**STAFF REPORT: SEPTEMBER 8, 2021 MEETING**

**APPLICATION NUMBER: 21-7468**

**ADDRESS: 360 LODGE**

**SCOPE: REMOVE CONCRETE DRIVEWAY; NEW ASPHALT DRIVEWAY**

HDC Staff photo, September 1, 2021

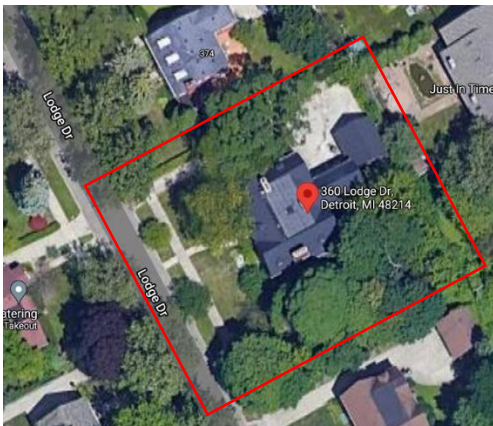
- The concrete and brick pavers lining the driveway were in place at the time of district designation.
- The concrete blocks between the street and the masonry pier do show some cracks but are primarily intact. From the sidewalk, and confirmed in the applicant's photographs, the concrete beyond the masonry piers are at a higher level of deterioration.

It is staff's opinion the removal of the concrete and brick lined driveway and installation of an asphalt driveway will alter the features and spaces that characterize the property. Staff therefore recommends the Commission deny a Certificate of Appropriateness for the work as proposed because it does not meet the Secretary of the Interior Standards for Rehabilitation and the Elements of Design for the district, specifically Standards:

2019 Google Street View of HDC-approved asphalt (over concrete) driveway at left, approved in 2000.

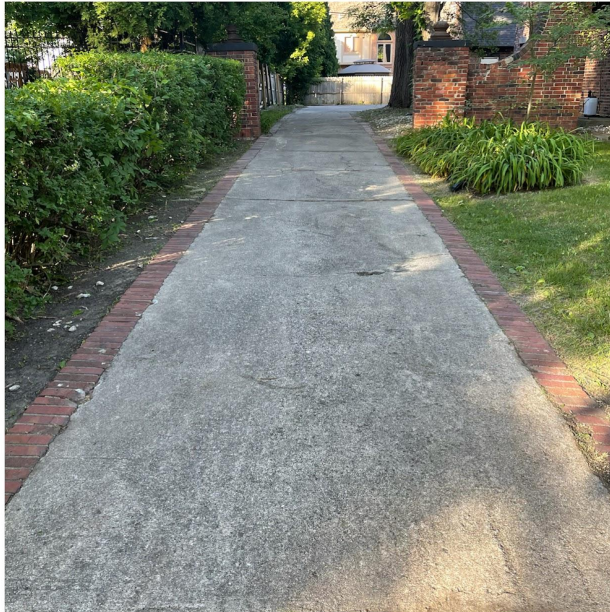
- Staff conducted a windshield survey and counted 11 asphalt driveways in the district (out of 106 parcels) – approximately 10 percent.
  - According to the city's DPI system, the HDC reviewed only one of the driveways and issued a Certificate of Appropriateness in 2000. The COA states it was approved as the project met Standard #9: "*New additions, exterior alterations, or related new construction shall not destroy historic materials that characterize the property. The new work shall be differentiated from the old and shall be compatible with the massing, size, scale, and architectural features to protect the historic integrity of the property and its environment.*"
